Memorandum to the City of Markham Committee of Adjustment

January 8, 2021

File: A/092/20
Address: 19 Thorny Brae Drive – Markham, ON (Thornhill)
Applicant: Elina Eidkham
Agent: MDI Development Inc.
Hearing Date: January 20, 2021

SURVEYOR'S REAL PROPERTY REPORT
 PART 1
 PLAN OF
LOT 200
 REGISTERED PLAN 7695
 IN THE
 CITY OF MARKHAM
 (REGIONAL MUNICIPALITY OF YORK)

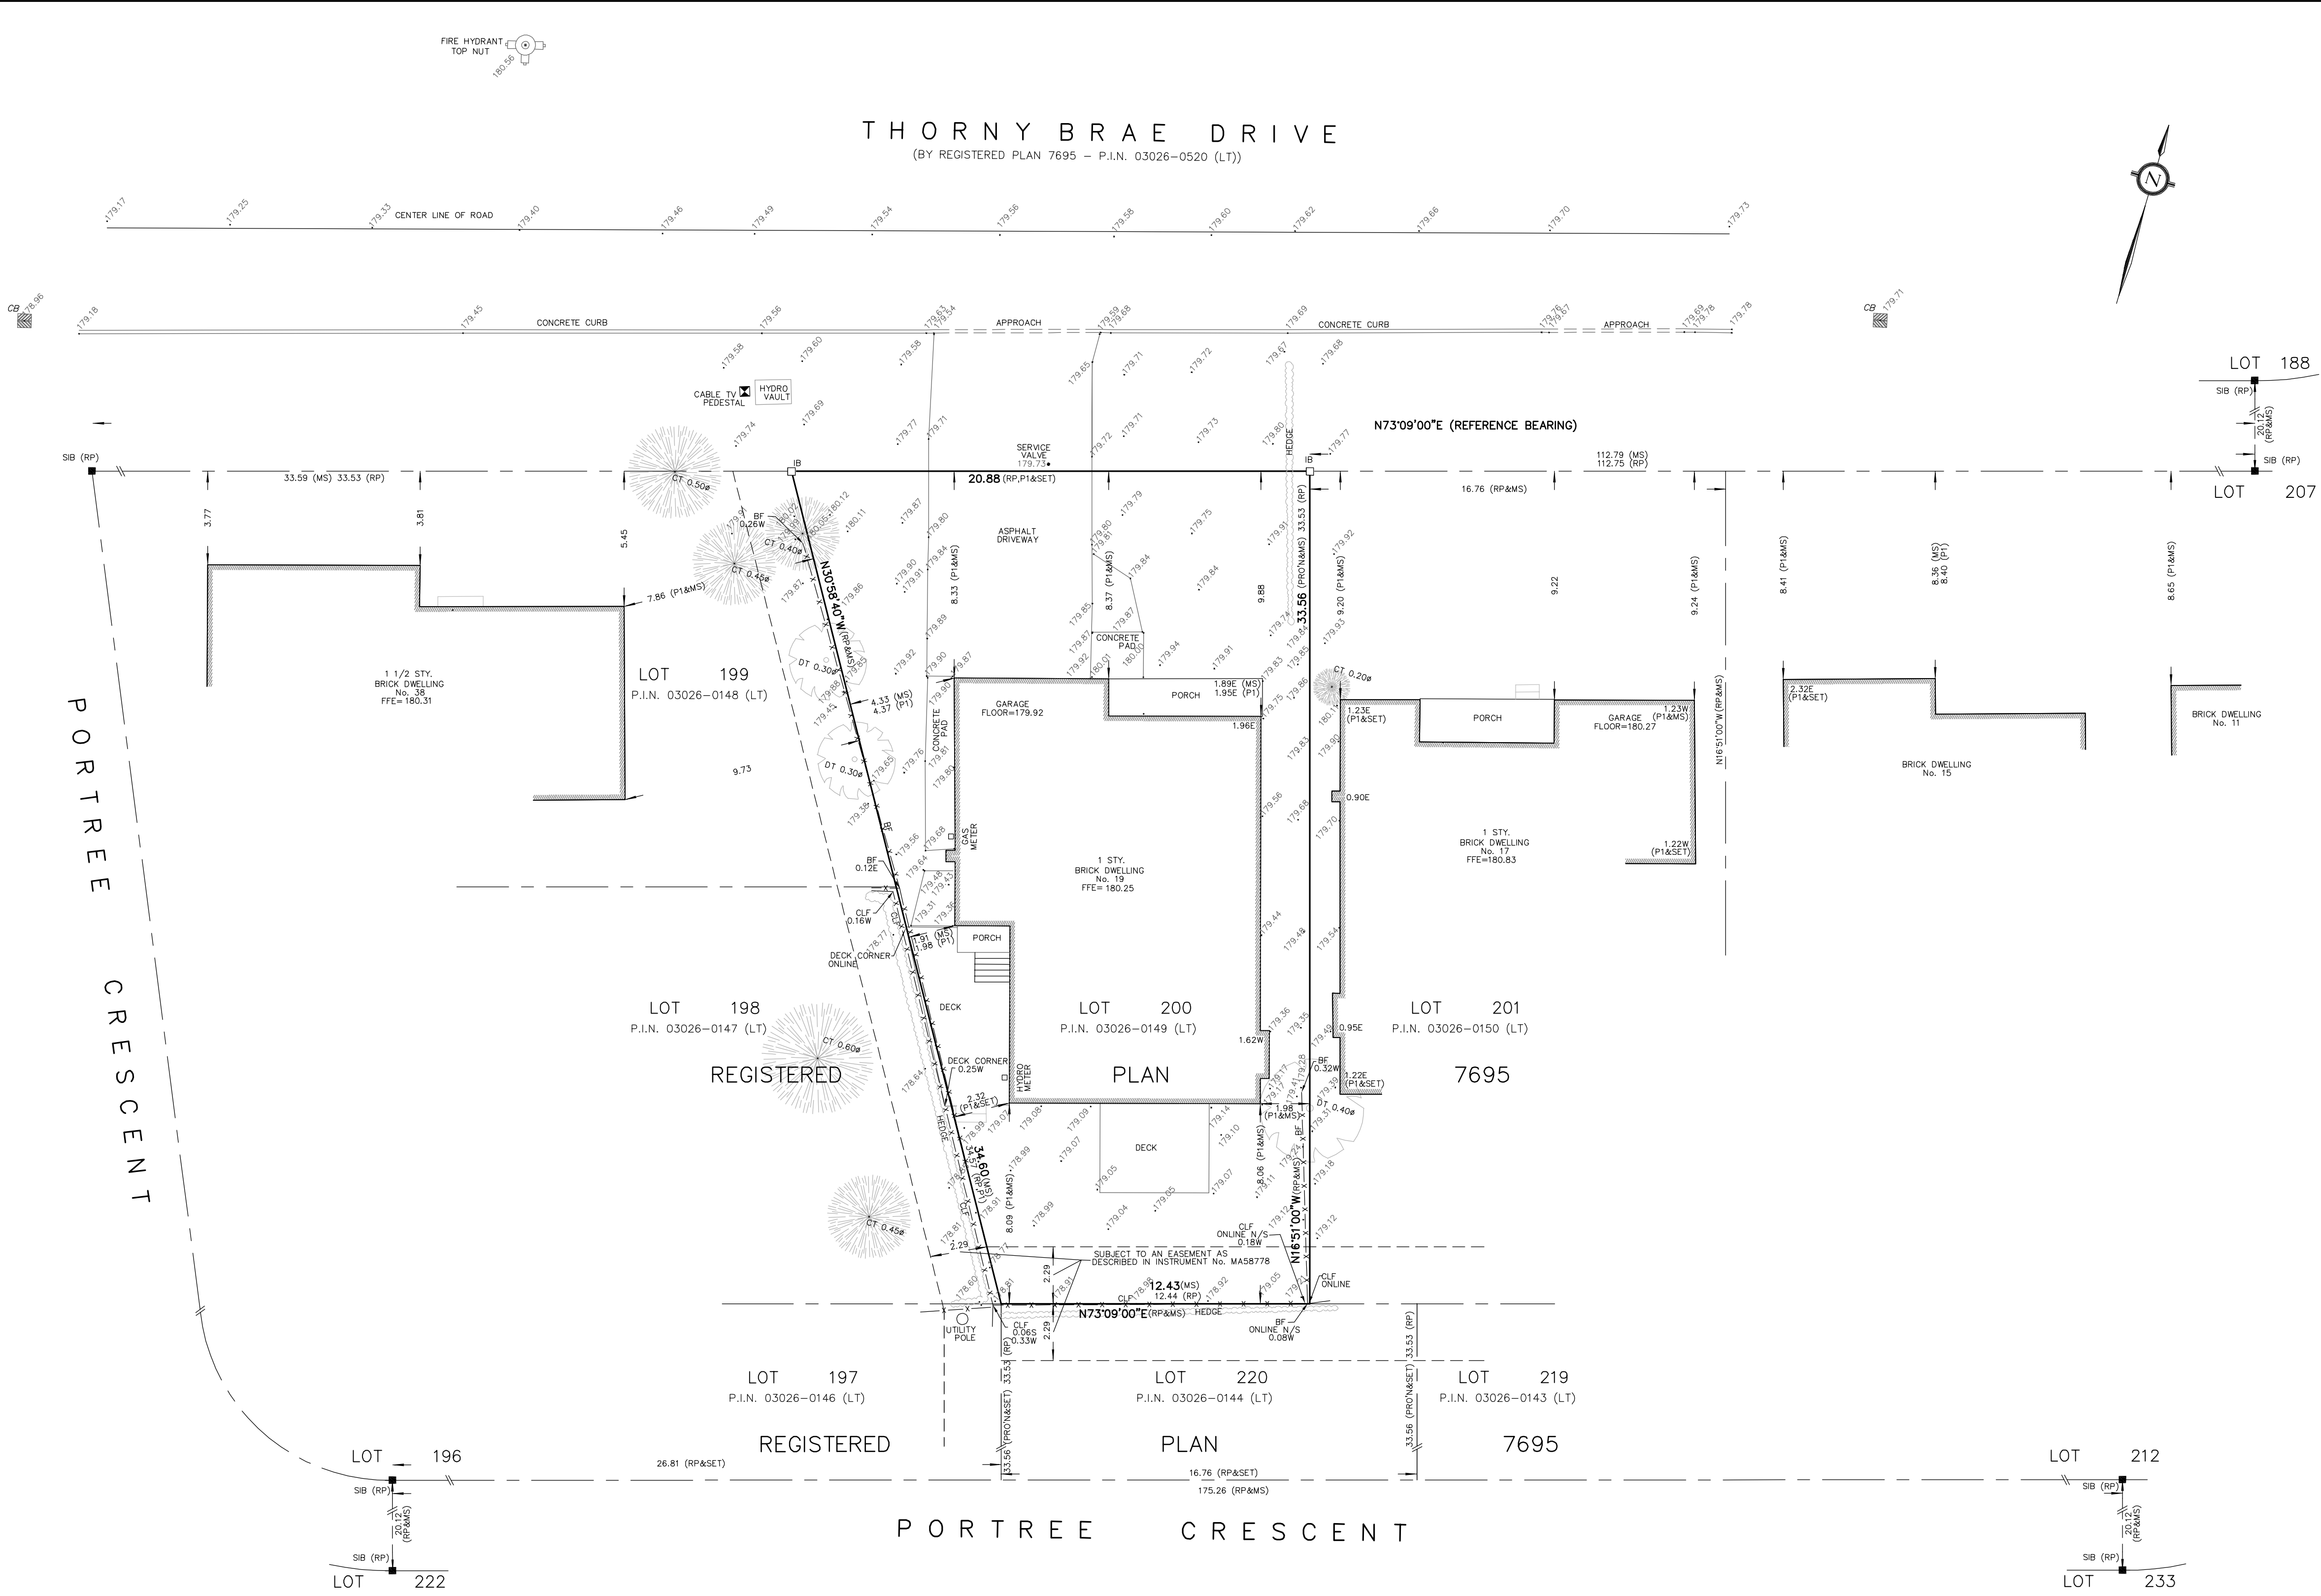
Mature trees and vegetation are primarily located along the east and west property lines, as shown in the survey (Appendix "B"). Urban Forestry staff have reviewed the application with respect to the proposed development. Staff recommend that tree protection and compensation conditions attached as Appendix "A" be adopted by the Committee in the event of approval.

1 SITE PLAN
A-0 SCALE 1/8"=1'-0"

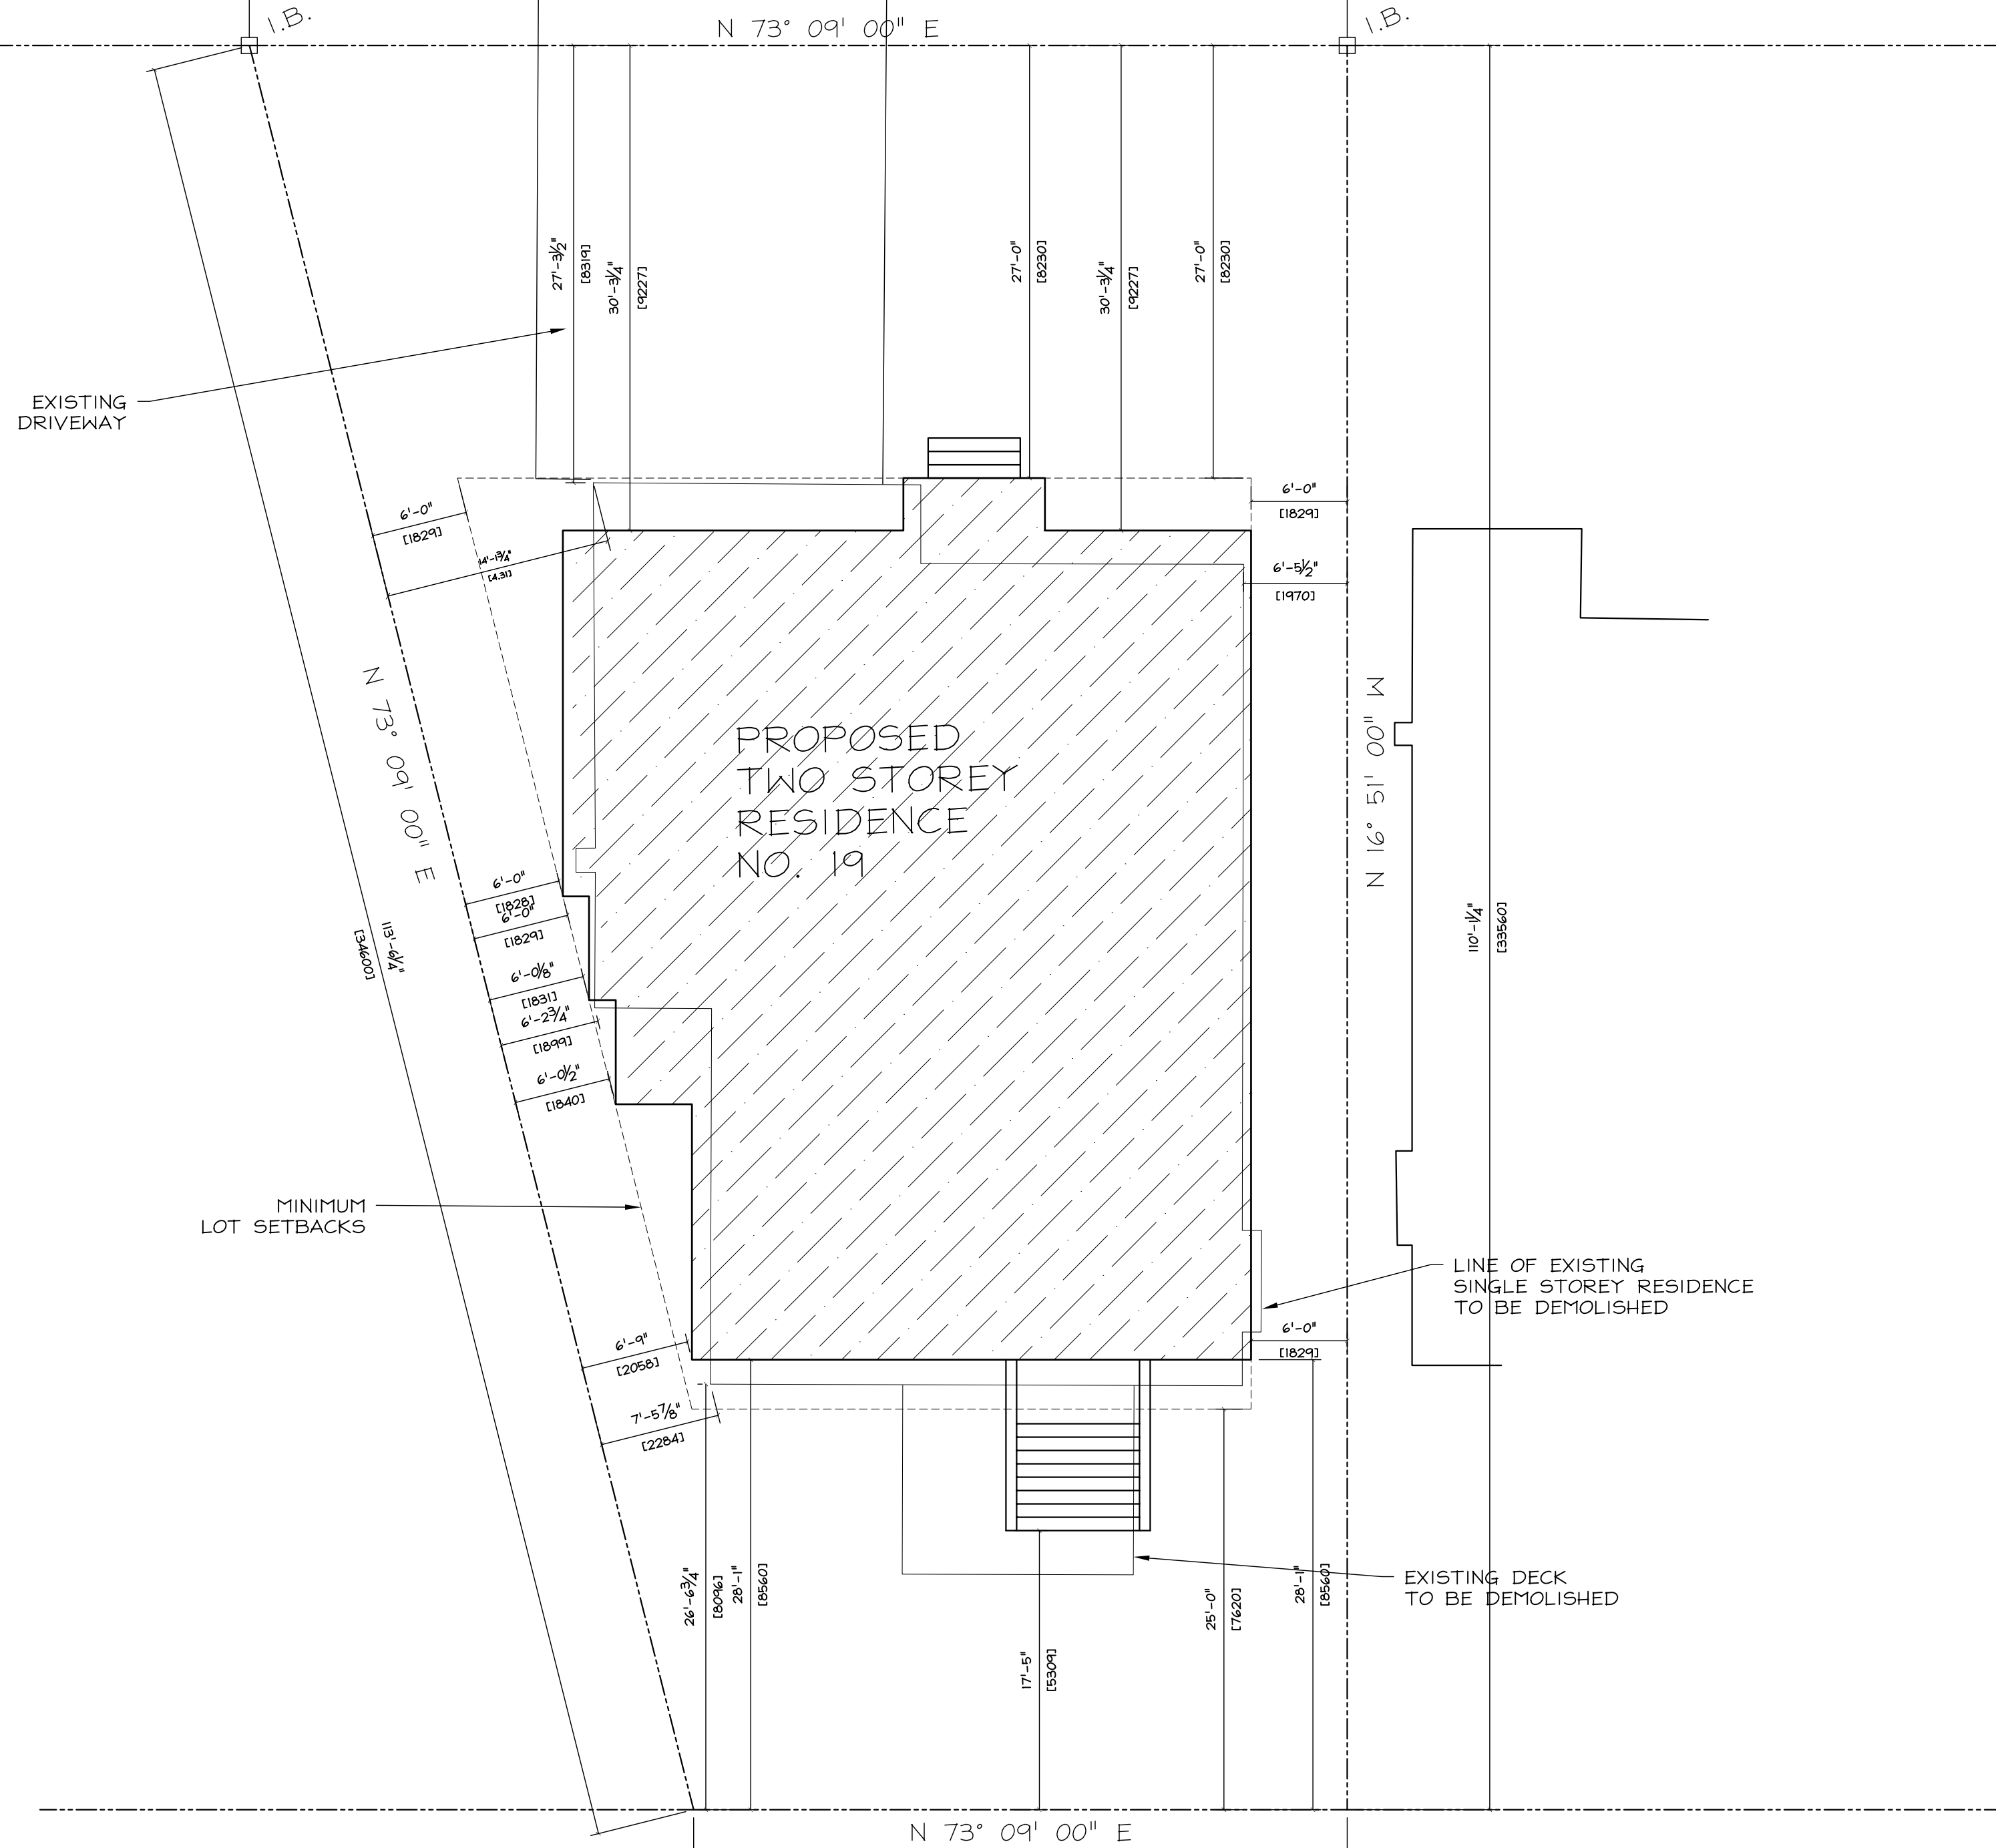
Increase in Maximum Lot Coverage

The applicant is requesting relief for a maximum lot coverage of 34.76% or a floor area of 193.27 m² (2,091.07 ft²), whereas the By-law permits a maximum lot coverage of 33.33%

or a floor area of 186.27 m² (2005.04 ft²). This is an increase of approximately 1.43% or 8.0 m² (86.03 ft²).

Staff are of the opinion that the proposed increase in lot coverage will not significantly add to the scale and massing of the dwelling, and the resultant dwelling is generally consistent with what the By-law permits.
